Access Compliance Report Public Rights-of-Way (Pedestrian Signals)

Main Street: CRAWFORD_CANYON_RD Cross Street: CHAPMAN_AVE Location: SW

ADA ID: SGRK211007170548 Signal Type: One Push Button-Non APS Overall Compliance: No Severity Scores: BTN 1: 10 BTN 2: N/A No BTN: N/A

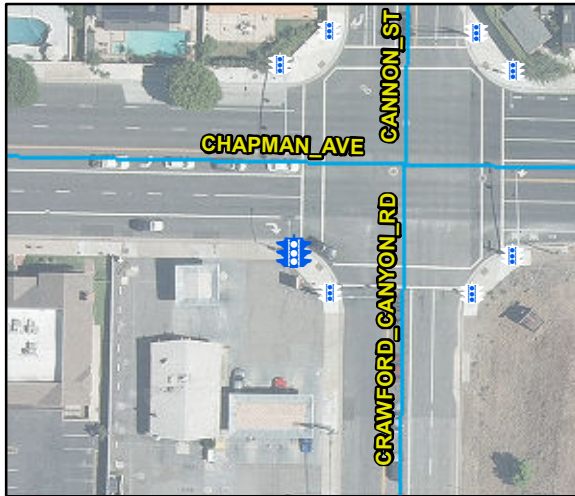
N/A Is Button 1 APS or Non-APS?	NonAPS	N/A Is Button 2 APS or Non-APS?	N/A
N/A B 1 VibroTact Arrow?	N/A	N/A B 2 VibroTact Arrow?	N/A
N/A B 1 VibroTact Parallel to Xing?	N/A	N/A B 2 VibroTact Parallel to Xing?	N/A
N/A B 1 VibroTact Contrast	N/A	N/A B 2 VibroTact Contrast	N/A
No B 1 Pilot Light?	No	N/A B 2 Pilot Light?	N/A
N/A B 1 Pilot Light Illumination?	N/A	N/A B 2 Pilot Light Illumination?	N/A
N/A B 1 Walk Indicator Type	N/A	N/A B 2 Walk Indicator Type	N/A
N/A B 1 Walk Indicator Audible?	N/A	N/A B 2 Walk Indicator Audible?	N/A
N/A B 1 Locator Tone?	N/A	N/A B 2 Locator Tone?	N/A
N/A B 1 Tone Audible Range?	N/A	N/A B 2 Tone Audible Range?	N/A
B 1 Addl APS Features?	No	B 2 Addl APS Features?	N/A
B 1 Addl APS Features Notes	N/A	B 2 Addl APS Features Notes	N/A

Possible Solutions: Replace Signal Push Button With APS Button.
